DEVELOPMENT APPLICATION ASSESSMENT REPORT

Application Number:	DA2021/2651
----------------------------	-------------

Responsible Officer:	Thomas Prosser
Land to be developed (Address):	Lot 70 DP 24563, 92 Riverview Road AVALON BEACH NSW 2107
Proposed Development:	Demolition works and construction of a dwelling house including a swimming pool and use of an existing outbuilding as a home office/studio
Zoning:	C4 Environmental Living
Development Permissible:	Yes
Existing Use Rights:	No
Consent Authority:	Northern Beaches Council
Land and Environment Court Action:	No
Owner:	Harmen Sicco Pieter Fredrikze
Applicant:	Harmen Sicco Pieter Fredrikze

Figure 1: Section indicating Height non-compliance (of up to 9.46m).

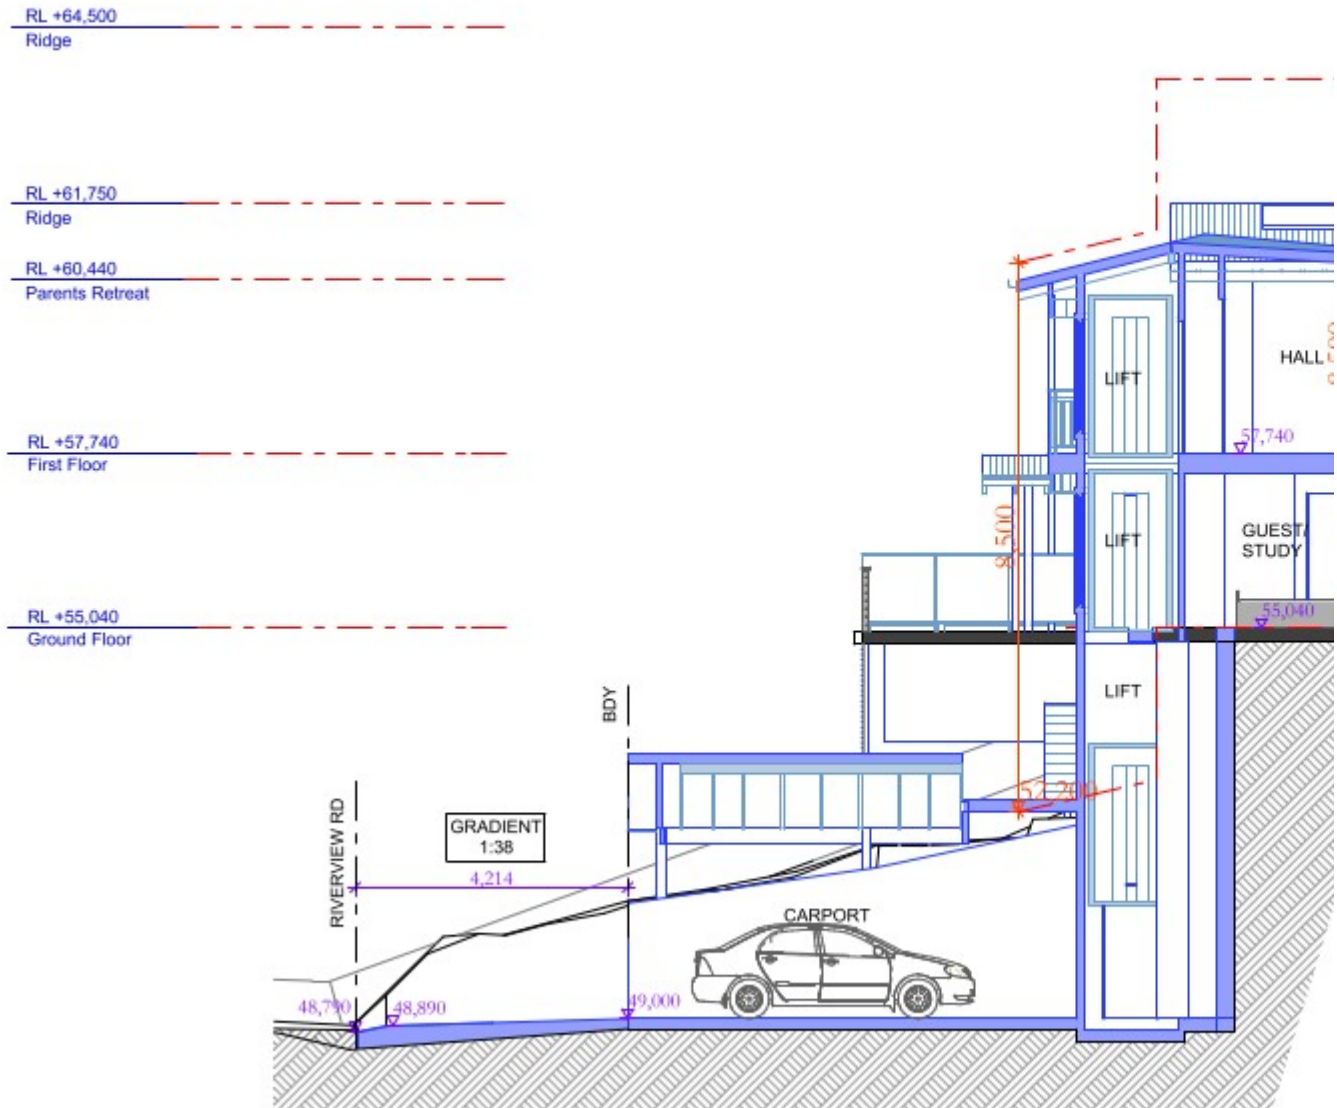
The proposal involves a minor section of the dwelling toward the rear of the envelope that does not comply with the building height standard. This is limited mainly to the roof form.

Figure 1: Representation on numerical non-compliance with building envelope control.

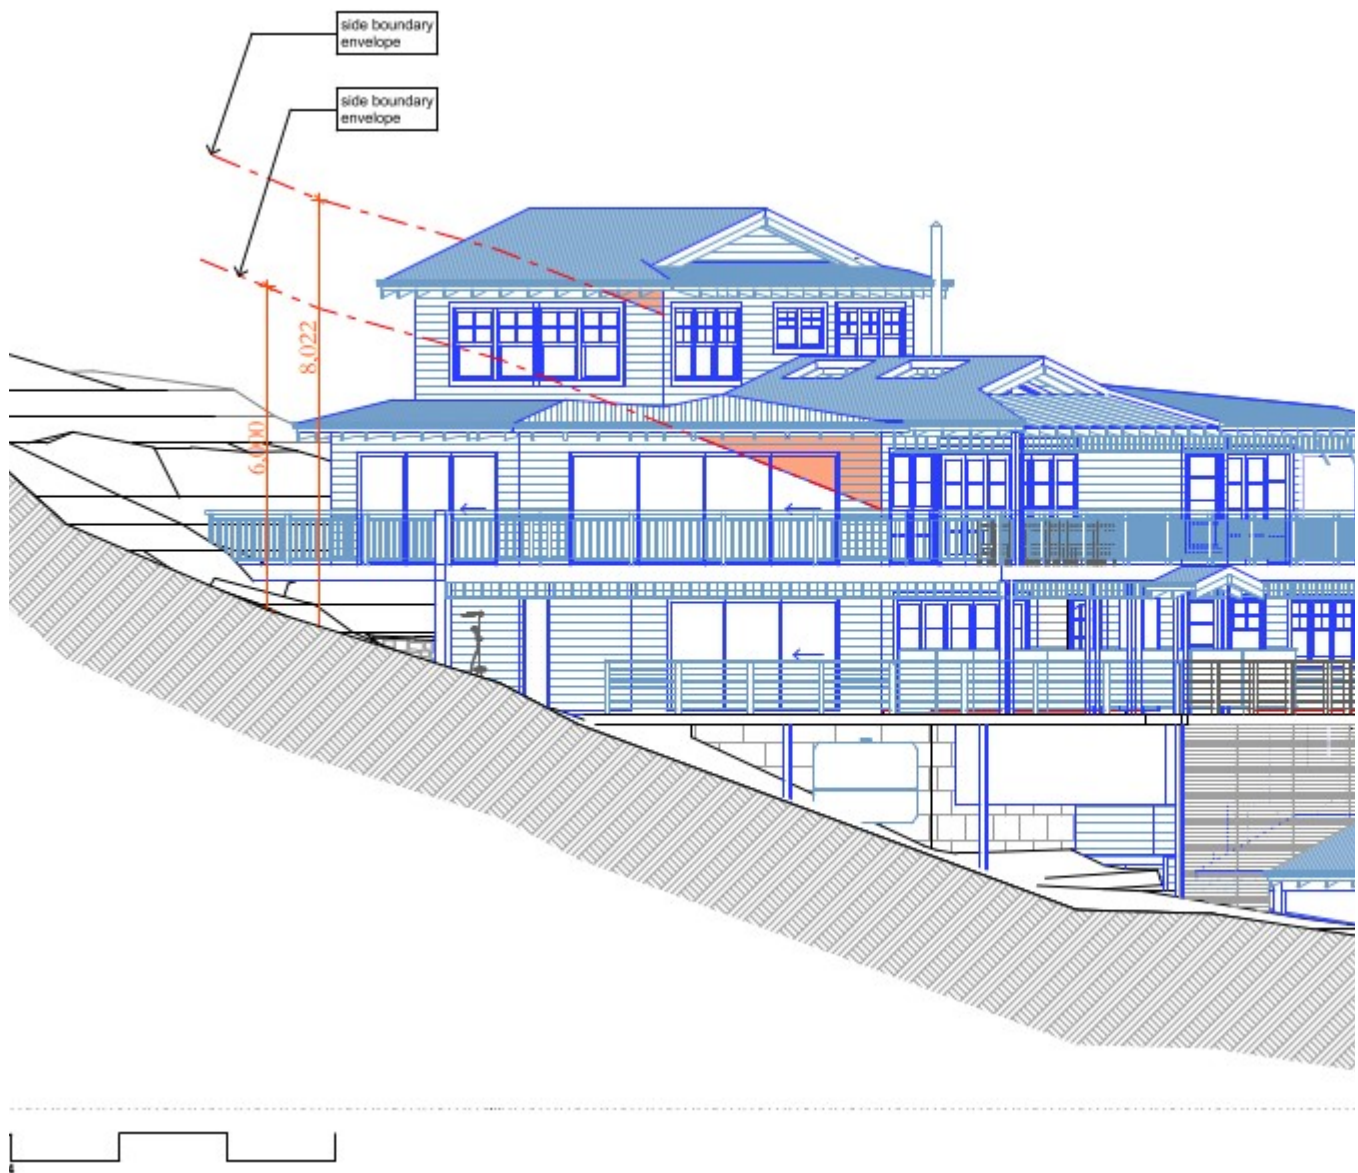
The proposal does not comply with the building envelope at the northern elevation. This is represented with the red highlighting in the diagram below:
